REGULATORY OBSERVATION	
REGULATOR TO COMPLETE	
RO unique no.:	RO-ABWR-0034
Date sent:	16th December 2014
Acknowledgement required by:	9th January 2015
Agreement of Resolution Plan Required by:	6th February 2015
Resolution of Regulatory Observation required by:	<i>To be determined by the Hitachi-GE resolution plan</i>
TRIM Ref.:	2014/460897
Related RQ / RO No. and TRIM Ref. (if any):	RQ-ABWR-0082, TRIM 2014/118089
Observation title:	Demonstrating the inclusion of a 'bottom drain line' in the UK ABWR design achieves inherent safety and reduces risks SFAIRP
Technical area(s) 9. Reactor Chemistry	Related technical area(s) 10. Radiation Protection & (Level 3 PSA) 12. Structural Integrity
<i>Regulatory Observation</i>	
SUMMARY	
<p>The United Kingdom Advanced Boiling Water Reactor (UK ABWR) currently includes a design feature referred to as the 'bottom drain line'. The line is located at the bottom of the Reactor Pressure Vessel (RPV) and is connected to the Reactor Water Clean-up System (RWCU).</p> <p>During Step 2 of the Generic Design Assessment (GDA) of UK ABWR, a Regulatory Query (RQ), (RQ-ABWR-0082 [1]), was raised in the reactor chemistry area which requested Hitachi-GE to explain

Figure 1: Depiction of the RWCU for UK ABWR [3]

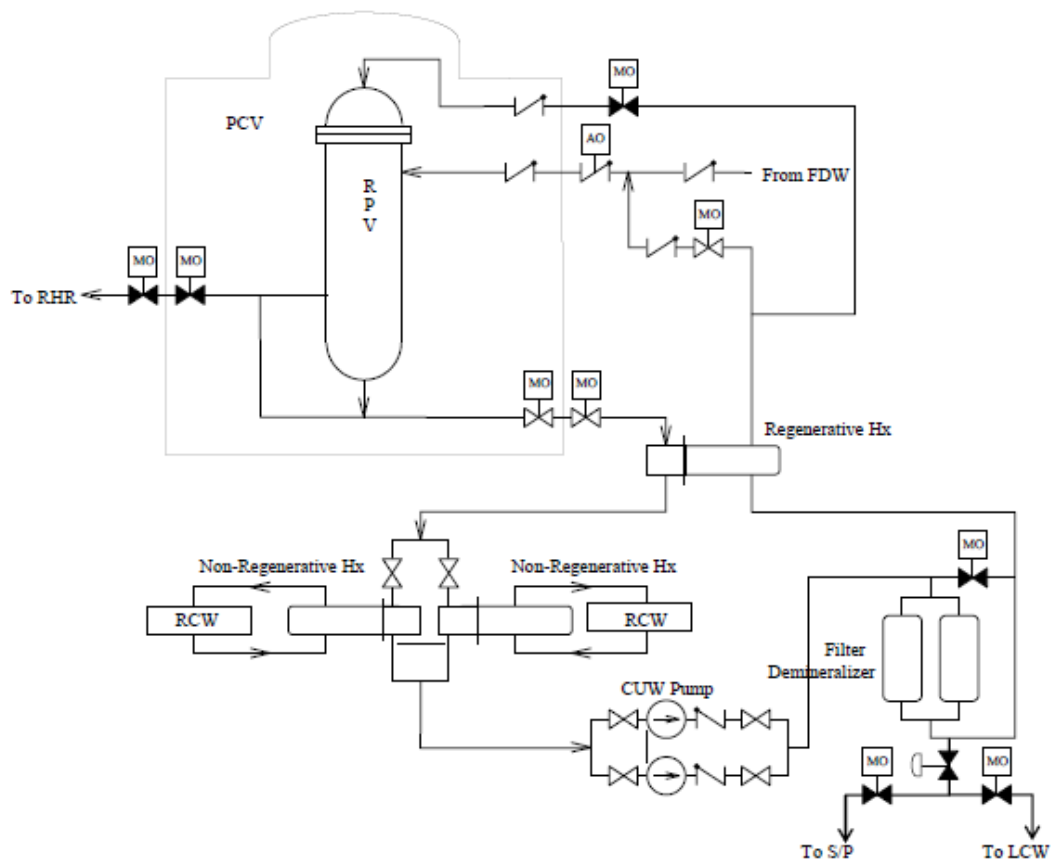
ONR has subsequently undertaken further assessment work related to this aspect of the design, the outcome of which confirms that such features are significant sources of dose and also challenges the reasons originally put forward for the inclusion of the ‘bottom drain line’ for UK ABWR. In summary, ONR has found that:

- a. All German Boiling Water Reactors (BWRs) have permanently closed the drain openings at the RPV bottom [4];
- b. All Swedish BWRs that were originally designed with a ‘bottom drain line’ have now permanently closed them, principally because;
 - Operating Experience Feedback (OPEX) has shown the line was not required in practice and

- was a large contributor to worker dose uptake during the outage;
- The line was originally intended to drain CRUD (Chalk River Un-identified Deposit) which may accumulate in the bottom of the RPV, but OPEX showed CRUD accumulation did not prove problematic [5].
- c. The design of all Swedish internally pumped BWR plants (similar to the UK ABWR design) does not include a 'bottom drain line' [5];
- d. Some BWRs in the United States of America (USA) have also permanently closed the drain openings at the RPV bottom;
- e. Water chemistry control for the UK ABWR is claimed to minimise the formation of CRUD [6].

This RO has therefore been raised to make clear ONR's expectations regarding Hitachi-GE's justification for the inclusion of a 'bottom drain line' in the UK ABWR, specifically whether this achieves an inherently safe design which avoids radiological hazards rather than controlling them, and whether its presence reduces risks SFAIRP.

ONR expect Hitachi-GE to provide a robust demonstration that the inclusion of a 'bottom drain line' in the UK ABWR design achieves inherent safety and reduces risks SFAIRP. ONR expect first and foremost, the safest option to be selected, unless it can be shown it is not reasonably practicable for that option to be implemented. ONR would expect Hitachi-GE to demonstrate:

RO-ABWR-0034.A1 – Hitachi-GE to provide a robust demonstration to show the inclusion of a 'bottom drain line' in the UK ABWR design achieves inherent safety and reduces risks SFAIRP
